SECTION 00003 – ADDENDUM NUMBER 5

DATE: **January 9, 2015**

RE: **REGIONAL EMERGENCY COMMUNICATIONS CENTER**
 2 COPPAGE DRIVE, WORCESTER, MA 01603

SHEET NUMBER:
SKA-02

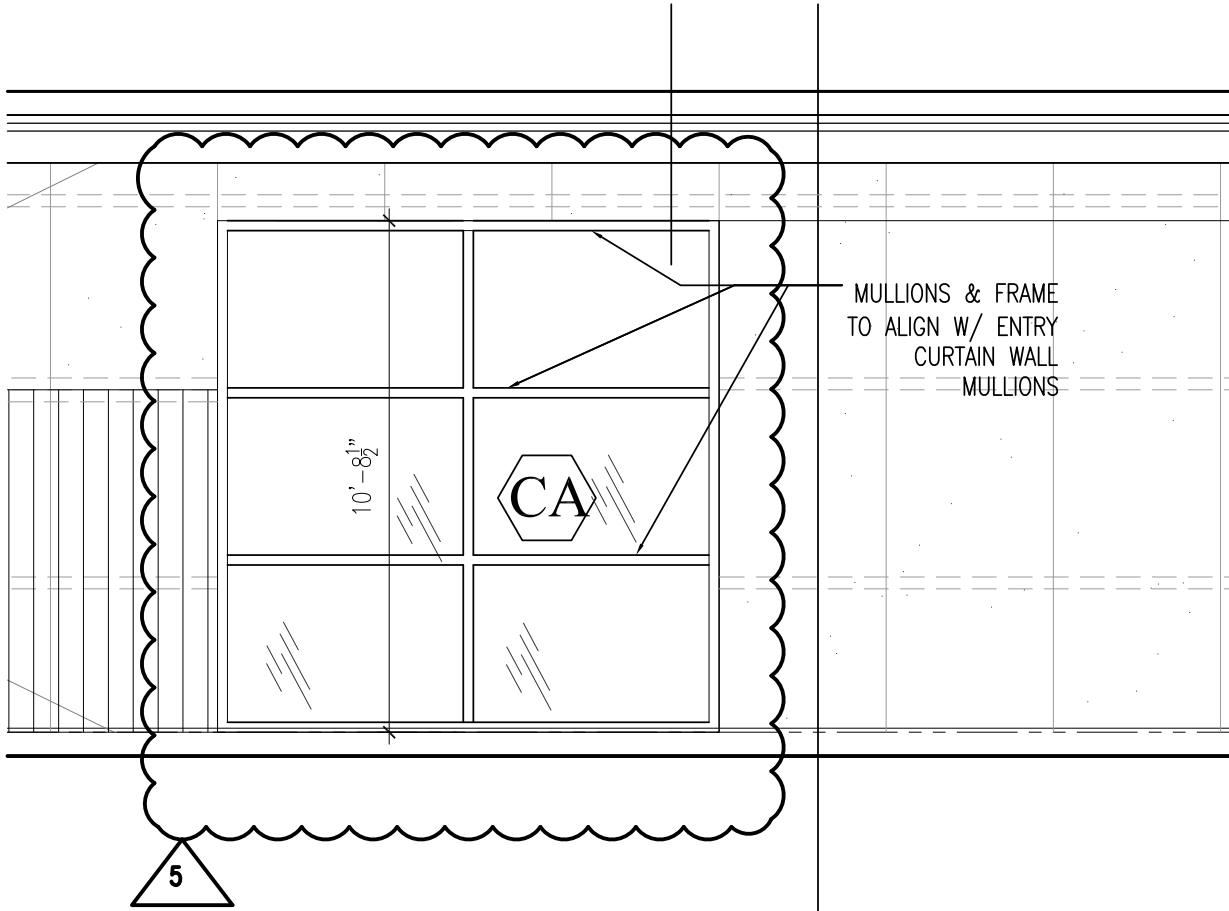
- 1. **SKA-02 WINDOW TYPE CA REVISION** Revise all drawings accordingly.

3.2 DRAWING A8.1: Change window types CA & DA storefronts to curtainwall. Provide provide 1-inch insulating glass in lieu of glass currently indicated.

- 4.3 QUESTION: Section 084413 –Types CA & DA not storefront CA glazed with ¼” tempered & DA glazed with ½” laminated glass. Is this correct? Is Insulated glass Req’d?

- 4.4 QUESTION: Depth of storefront not given. Is 2” x 4 ½” acceptable or 2 “ x 6” thermal or do you want 2 ½” x 7 ½” curtainwall?

ANSWER: *See 3.1 and 3.2 above.*

ANSWER: *Provide 6-inch deep curtain wall for window types DA and CA.*

MULLIONS & FRAME
TO ALIGN W/ ENTRY
CURTAIN WALL
MULLIONS
